Report No. EGG-EA-5252

Adequacy of Station Electric Distribution System Voltages, Trojan Nuclear Power Station, Docket No. 50-344, TAC No. 12957

TECHNICAL EVALUATION REPORT
ADEQUACY OF STATION ELECTRIC DISTRIBUTION SYSTEM VOLTAGES

TROJAN NUCLEAR POWER STATION

Figure 1
TROJAN NUCLEAR STATION
One-Line Diagram

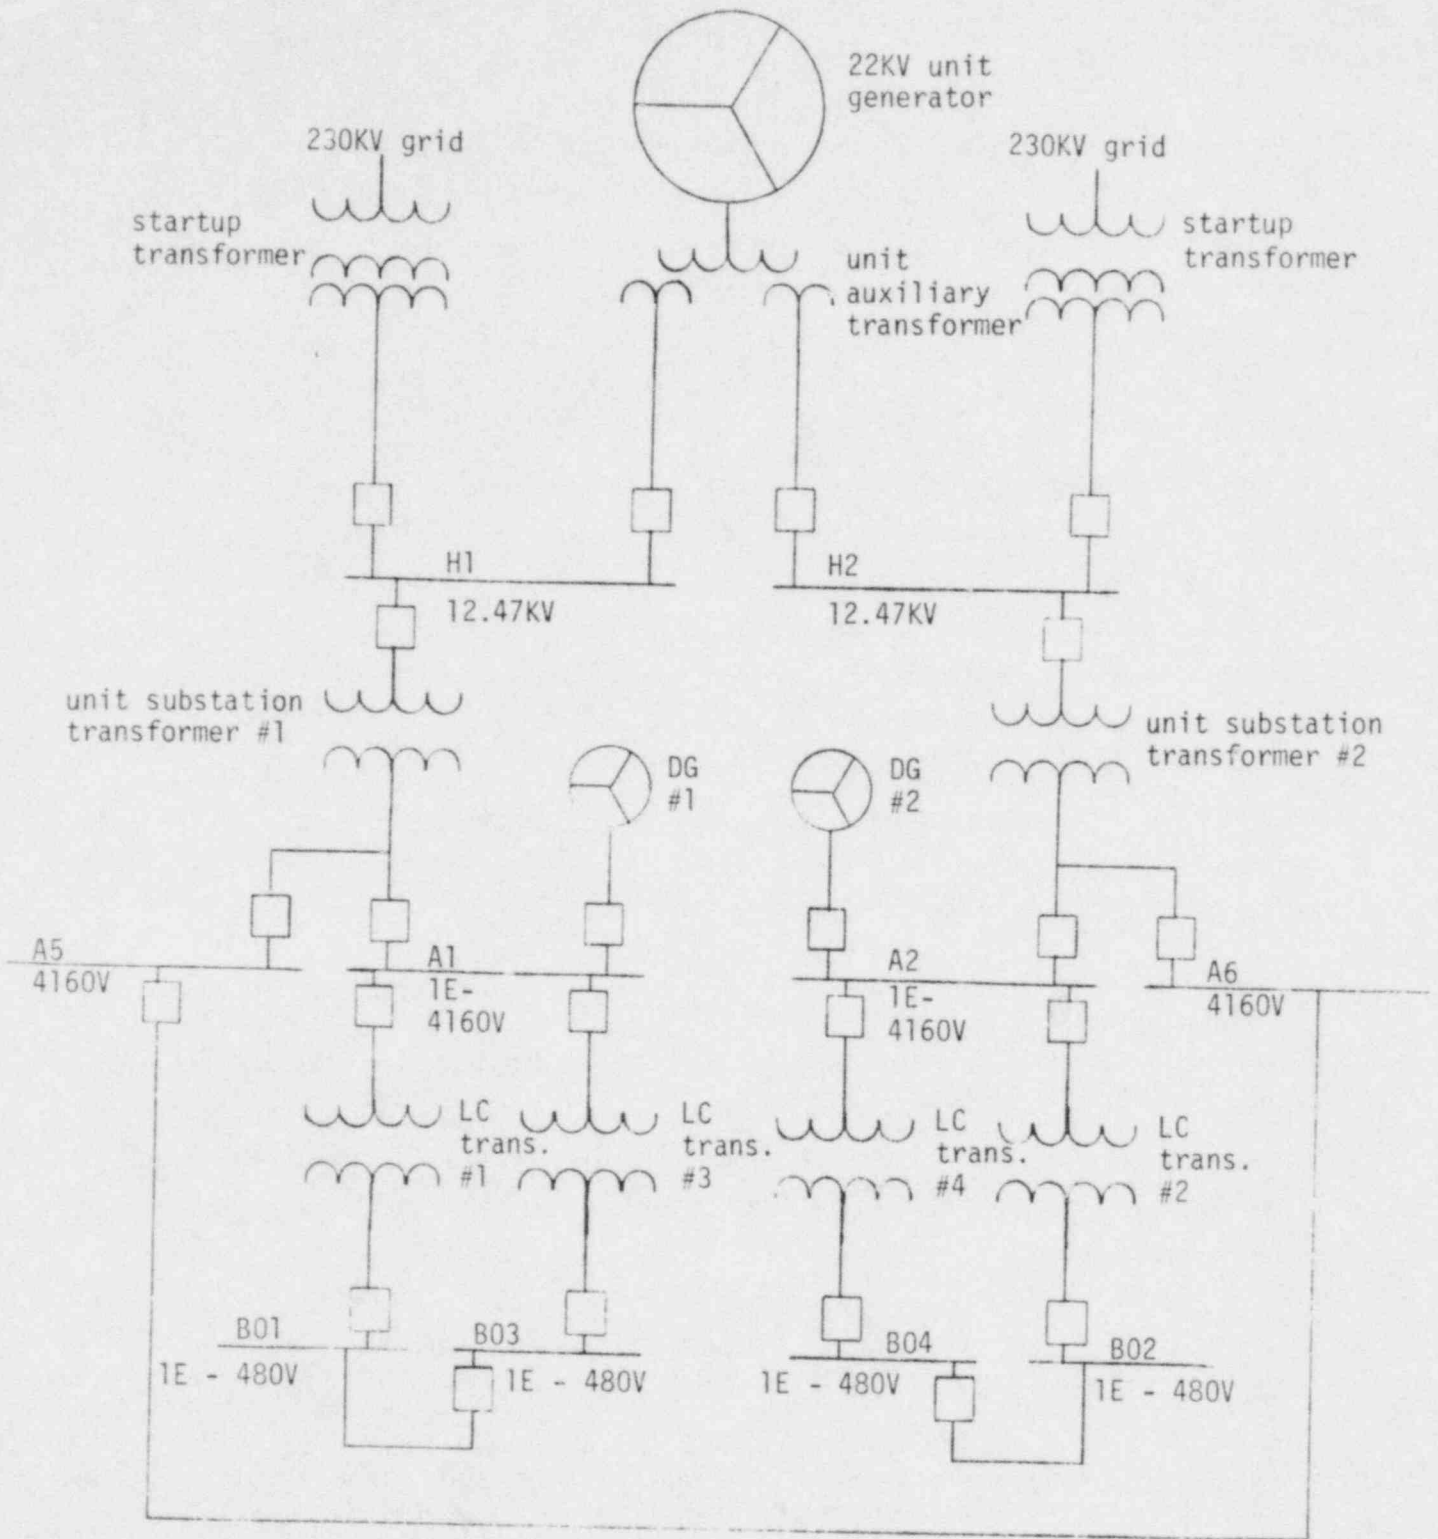
Each SUT normally supplies, as the preferred source, power for one redundant safety train and one-half of the plant auxiliary loads. However, as can be seen in Figure 1, an intertie between 4160V buses A5 and A6 exists. However, Technical Specification limiting conditions of operation limit the use of this intertie. Trojan periodic operating test POT-21-2 verifies that interties are not used.

4.1 Analysis Conditions. PGE has provided analyses for various conditions.^{2,5} The analysis for each condition was for the buses aligned to the normal source of power without use of bus interties. Since the Technical Specification 3.8.2.1, prohibits use of the interties between redundant buses during operation, the use of the interties between the class 1E buses were not analyzed.
